# Annual Review Manual 03A

Jeff Schmitt  
Manager, Power System Modeling Department  
RSCS  
September 16, 2022

Annual review of manual, non-substantive changes only  
clarifications and fixing errata

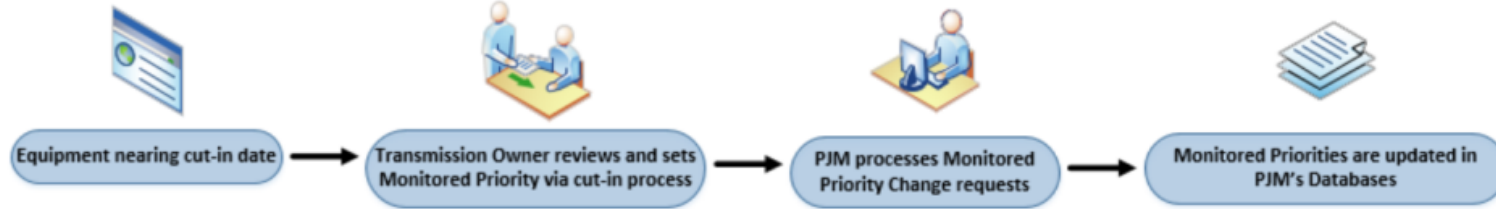
During our annual review we saw an opportunity for clarification (name) and increased efficiency for new equipment:

- This would allow us the following:
  - Avoid delays in energizing new equipment (cut-ins)
  - Provide a starting point for new equipment default
  - Provide clarity for monitored priority names & definitions
  - Document MP exceptions
- Annual MP Process does not change
- Only applies to “new” equipment (cut-in process)

Manual Revision:  
(Appendix C Exhibit 14)

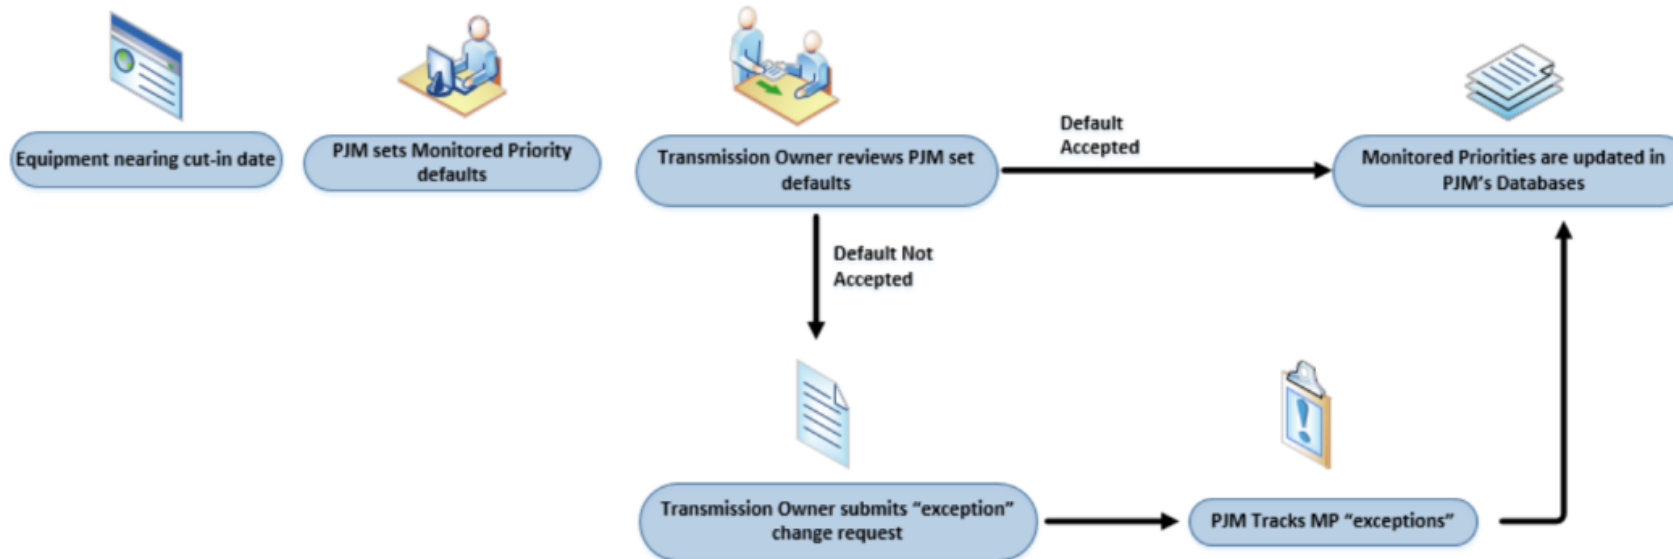
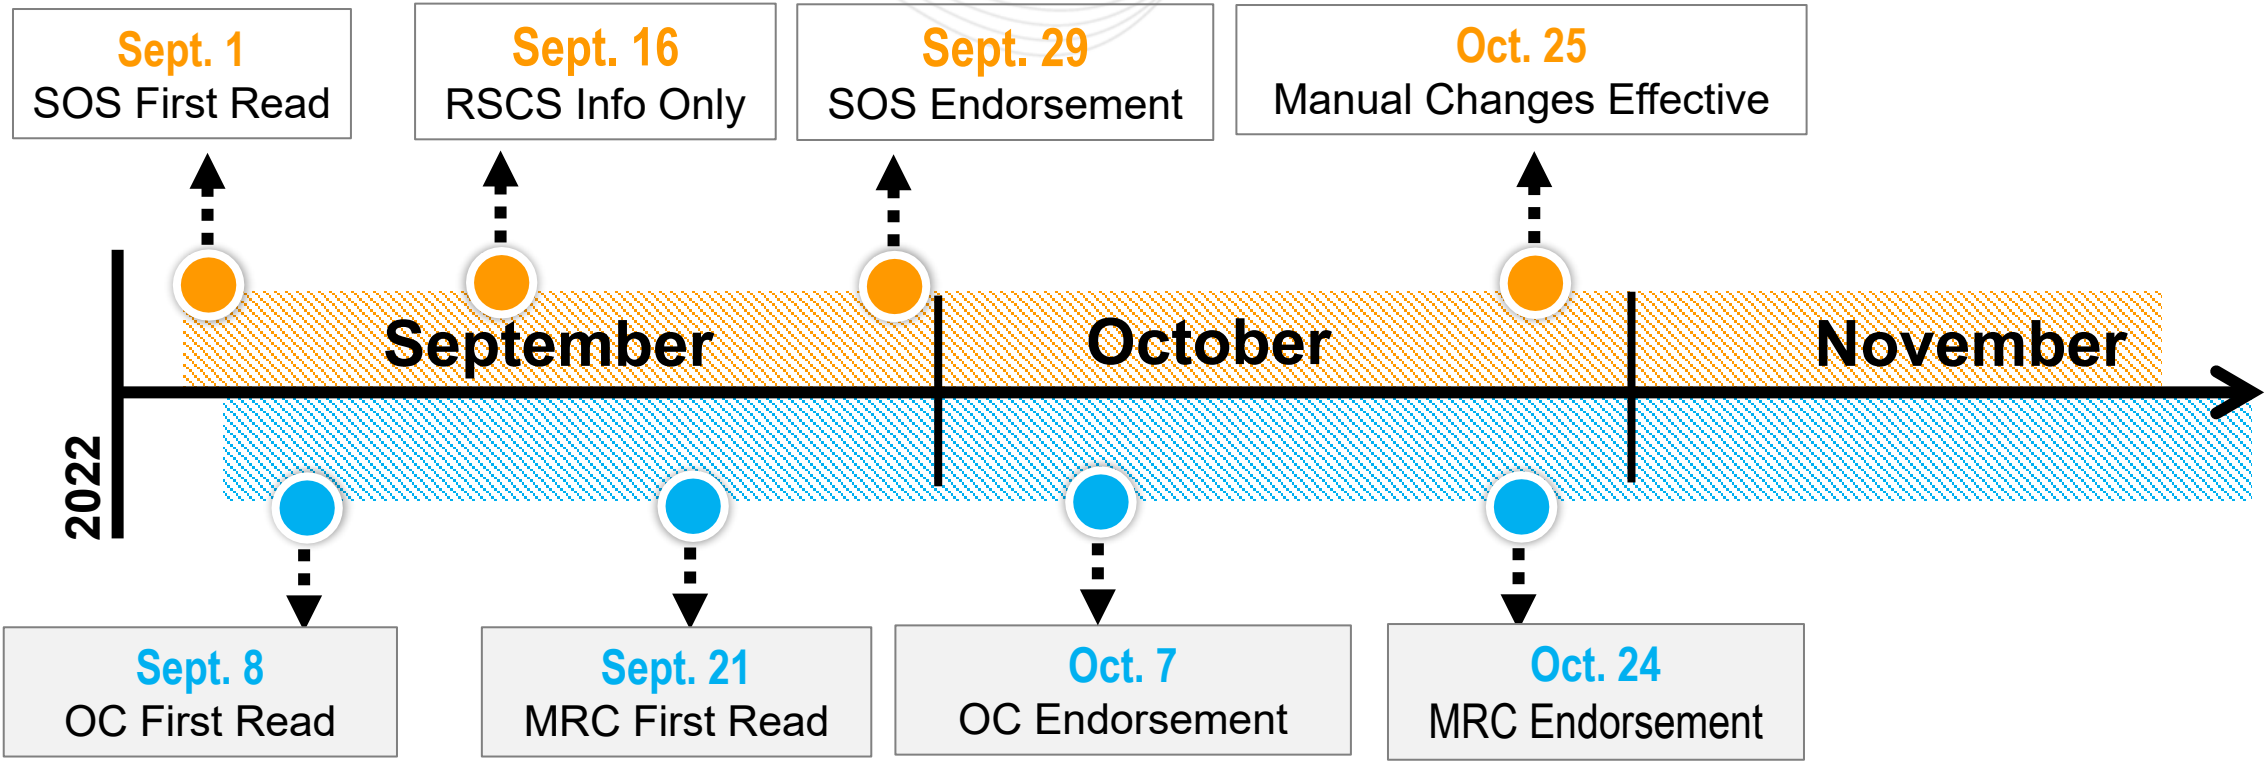
## CURRENT PROCESS:

## PROPOSED PROCESS:

- External “MP4” to External Reliability “MP4”
- GSU “MP7” to Generation Equipment “MP7”
- Future “MP8” to Pending “MP8”
